Mask Set Errata for Mask 0M20A

This mask set errata applies to the mask 0M20A for these products:

- MC9S08RG60
- MC9S08RG32
- MC9S08RE60
- MC9S08RE32
- MC9S08RD60
- MC9S08RD32
- MC9S08RC60
- MC9S08RC32

Case 1

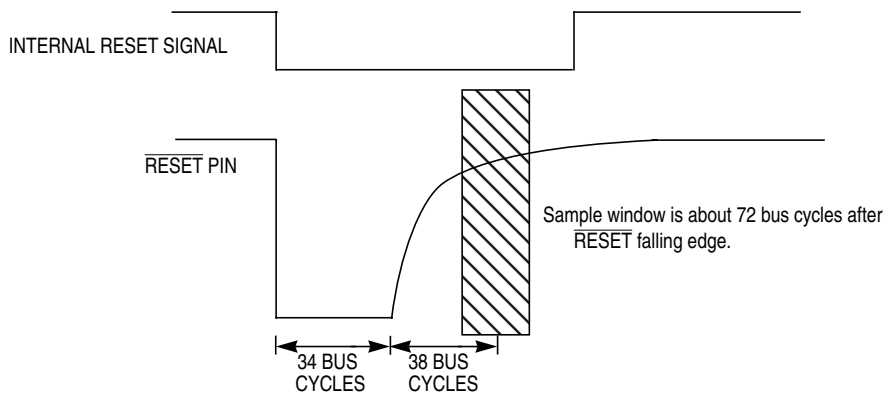
Case 1 — After detecting a reset signal, either internal or external, the internal reset circuit latches the cause of the reset, forces a low level on the external $\overline{\text{RESET}}$ pin for about 34 bus cycles, releases the pin, and samples the pin level about 38 bus cycles later.

To avoid multiple edges on the $\overline{\text{RESET}}$ pin due to switch contact ringing or EMC noise, eliminate any voltage bounce through RC filtering. A 0.1 μF capacitor to ground and an external 4.7 k Ω to 10 k Ω resistor to V_{DD} works well to ensure noise suppression.

Case 2

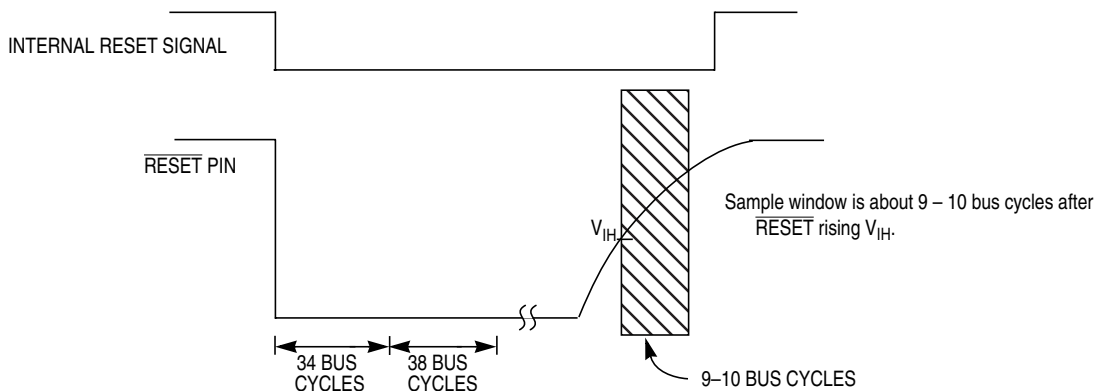
Case 2 — After remaining in reset for an extended period of time due to an externally applied low level on $\overline{\text{RESET}}$, the internal reset circuit will sample the pin level about 9 to 10 bus cycles after the pin raises above its V_{IH} level.

In addition to RC filtering, avoid spurious edges on the $\overline{\text{RESET}}$ pin caused by external active circuitry such as low voltage detectors and watchdog components. Do this by ensuring that external circuitry cannot drive $\overline{\text{RESET}}$ low within 10 bus cycles of the release of $\overline{\text{RESET}}$.
